City of Portland Design Commission

Design Advice Request

SUMMARY MEMO

Date: 3/30/2023
To: Josef West | West Architects, Inc.
From: Tanya Paglia, Design & Historic Review Team
503-865-6518 | Tanya.Paglia@portandoregon.gov
Re: EA 23-006886 DA – Maryland Apartments
Design Advice Request Commission Summary Memo – March 16, 2023

EA23-XXXXXX DA
C.7 - CONCEPT DESIGN: CANOPY AND PEDESTRIAN EXPERIENCE STUDY

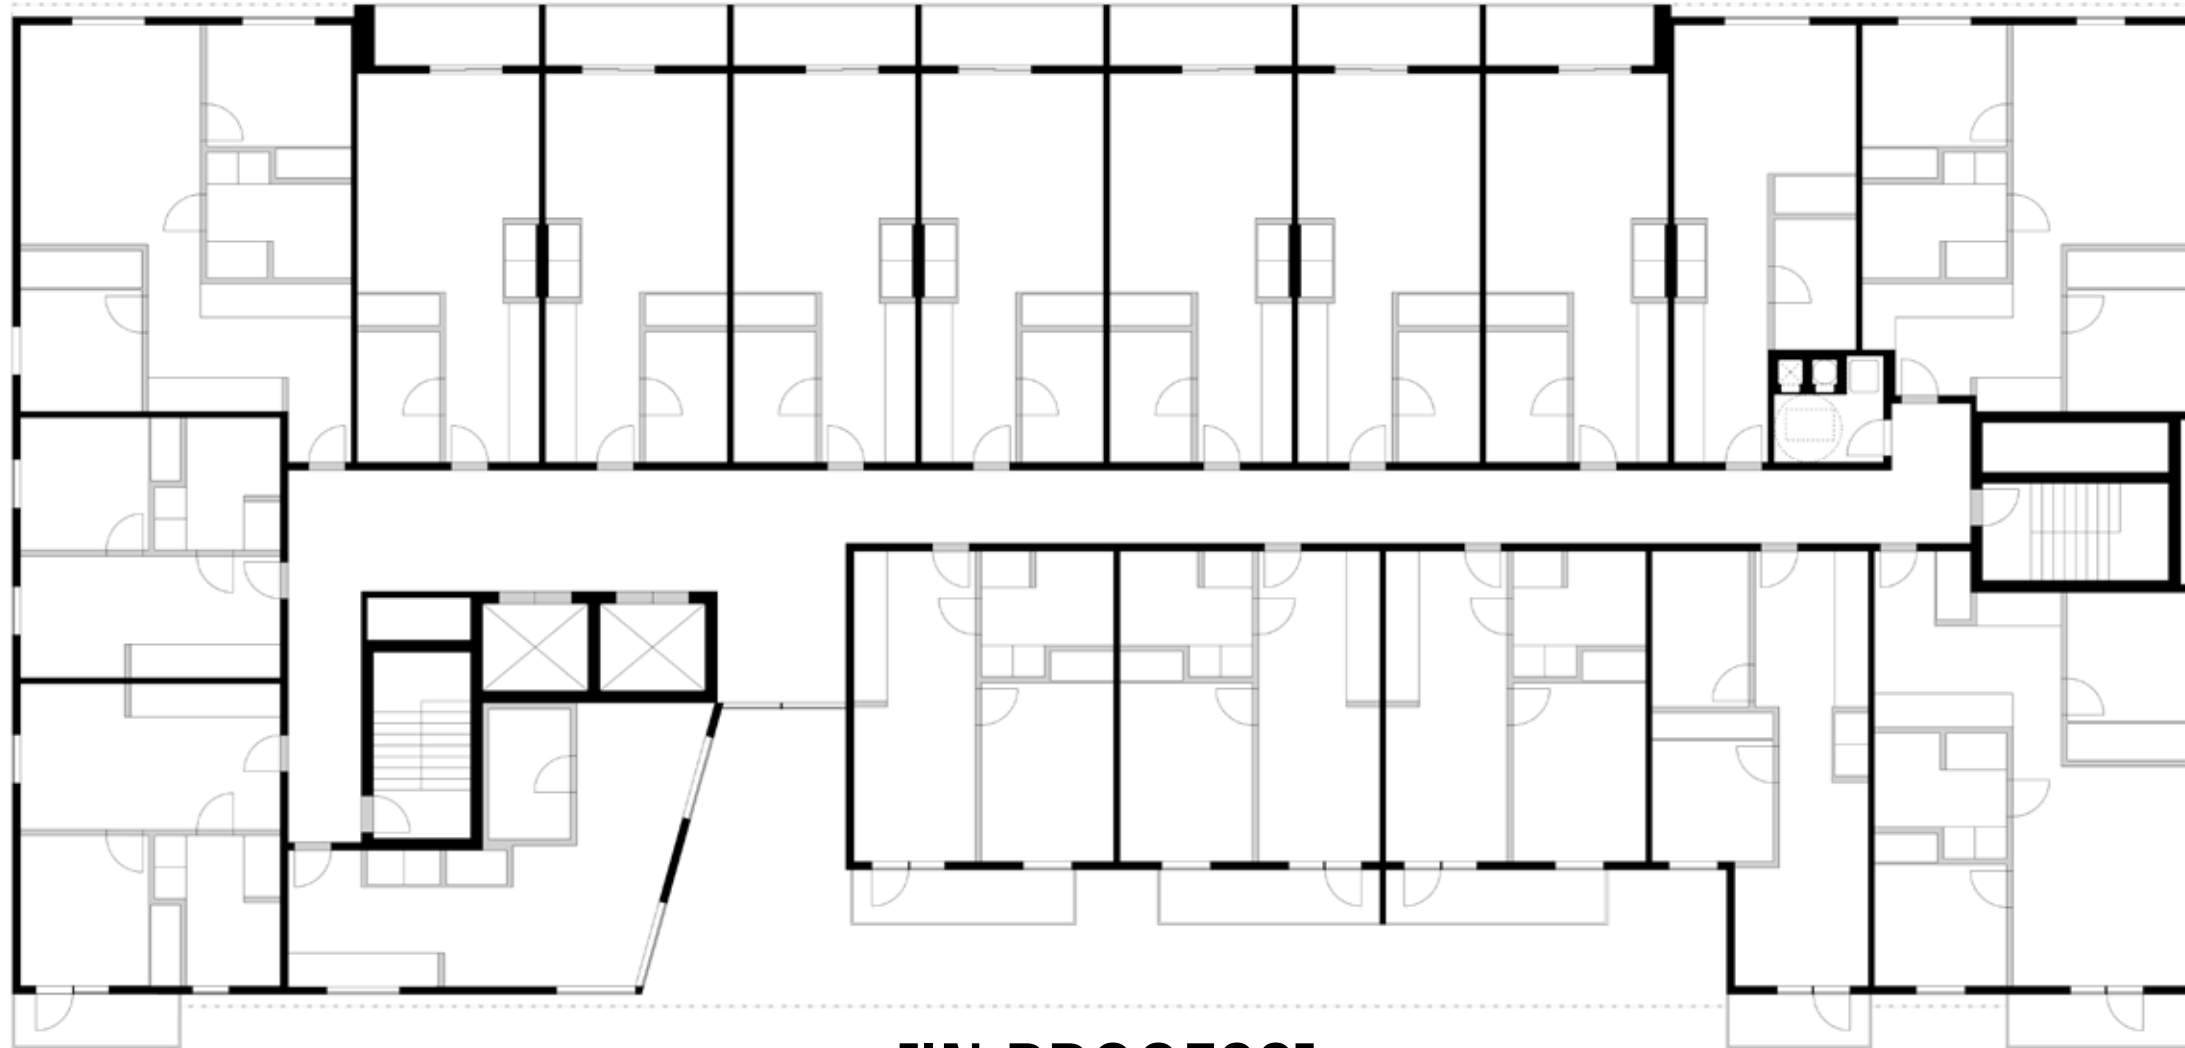
- Explore alternatives for the front canopy as the deep canopy with a thickly planted mass right above the patios can make the ground floor look squashed. It might work better to put

the canopy up higher, but it also might work to rethink the canopy plantings. Generally, 9'-6" is a nice canopy height, however, the clearstory glass above the canopy is obscured and gives the illusion that 9'-6" is too low which it normally isn't.
